Vintage Denim Apparel Ltd

Boherarchala, Sreepur, Gazipur-1740
(24.191601N, 90.403731E)

4th January, 2017

Tie Beam Cut-off at shed-01

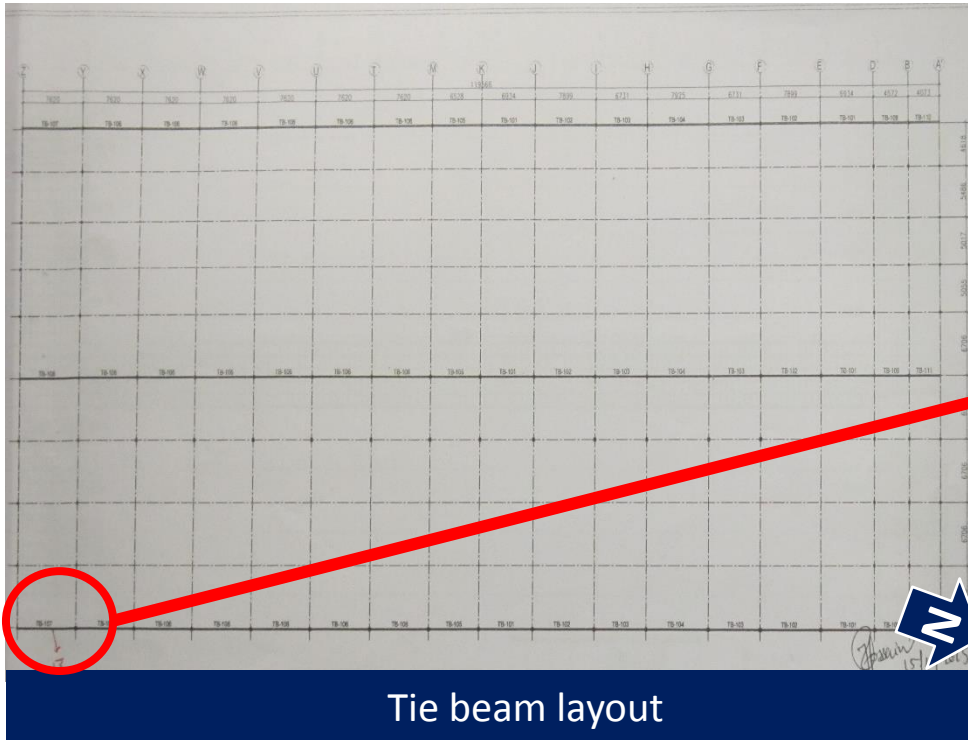
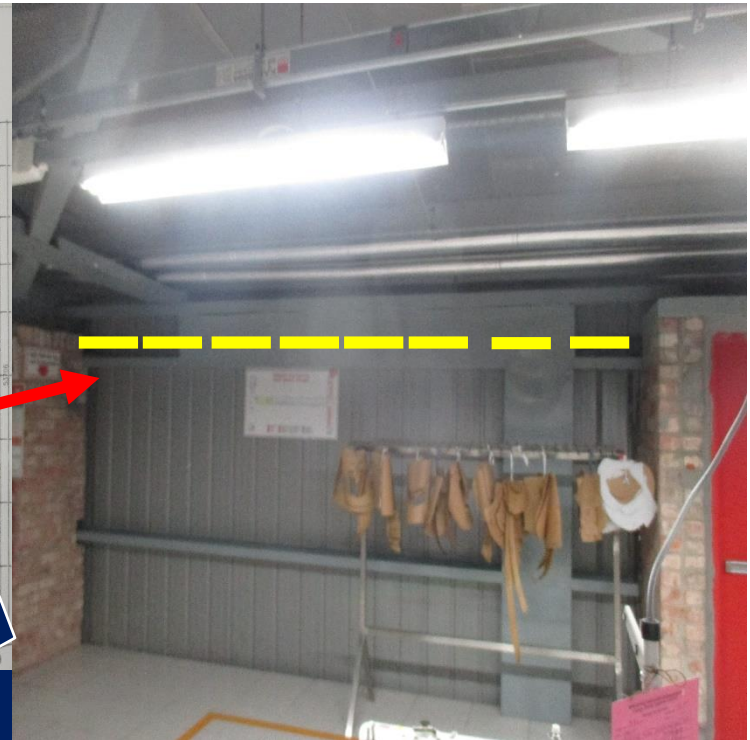
Tie beam discontinued at the highlighted area of Shed-01. Building engineer is required to take remedial measures.

Bracing missing at shed-03

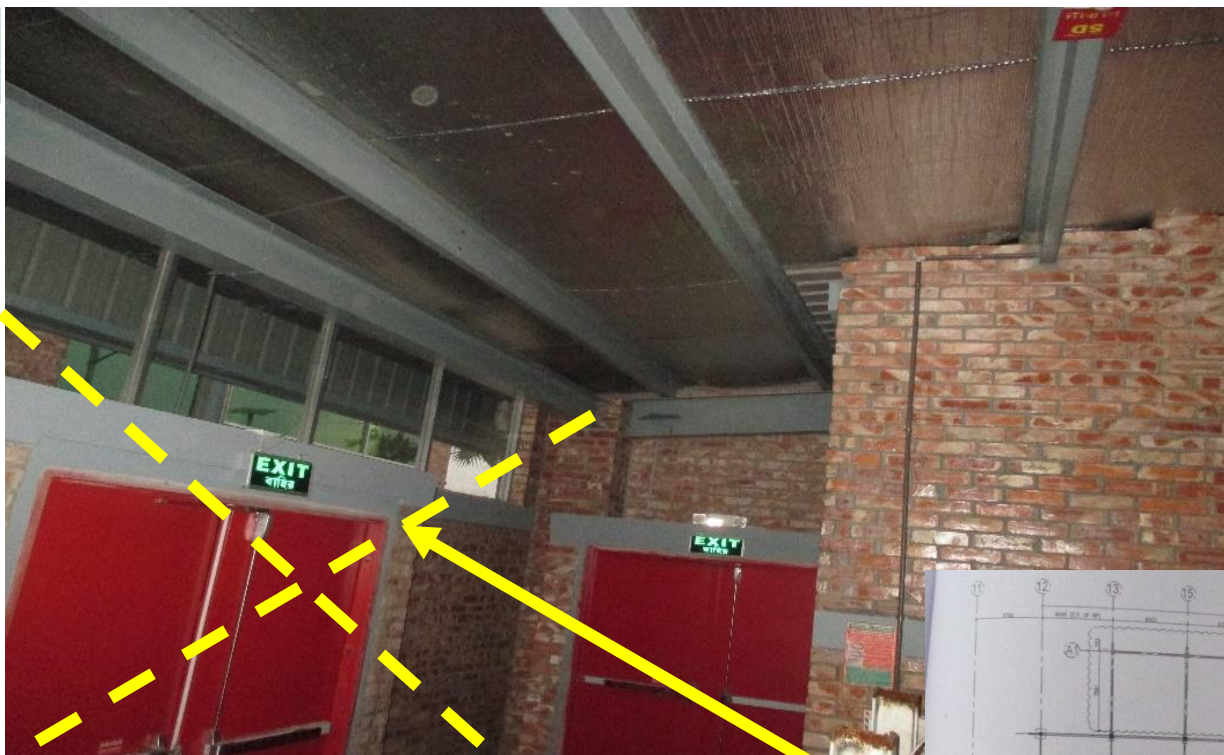
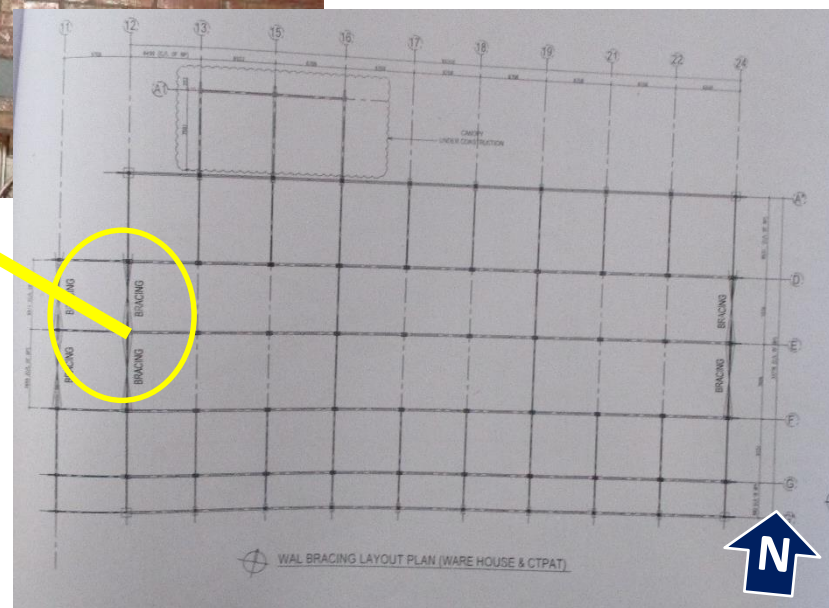
Wall bracing missing at shed-03. Building engineer is required to carry out installation work of bracing where necessary.

Existence of significant gap at connection

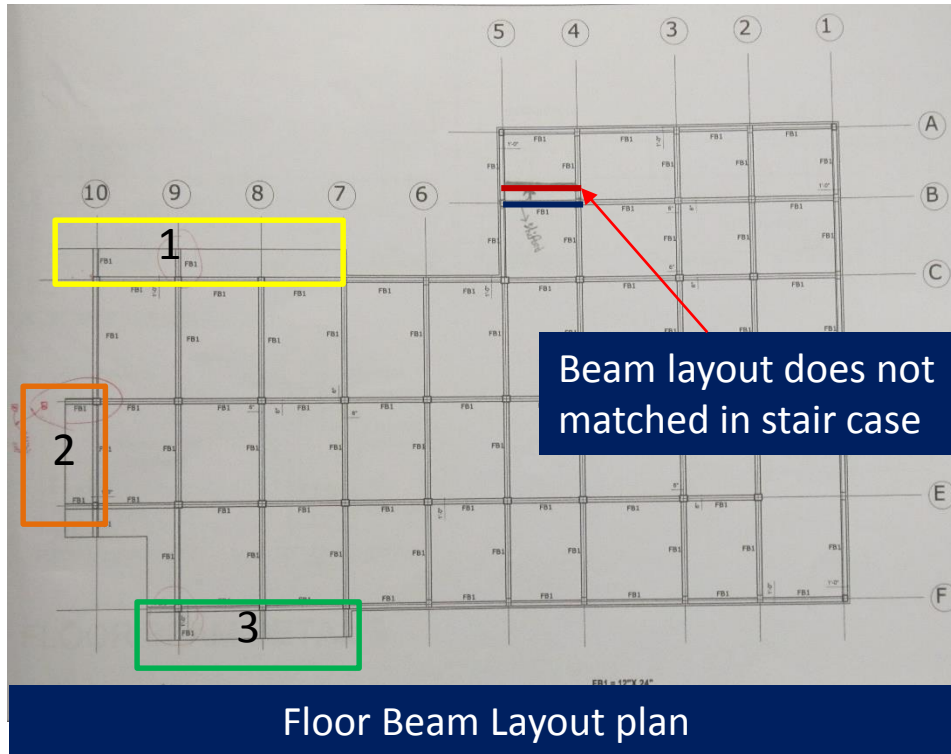
Significant gaps were observed in column-rafter joint and column tie-beam joint at several location. Building engineer is required to carry out suitable remedial works.
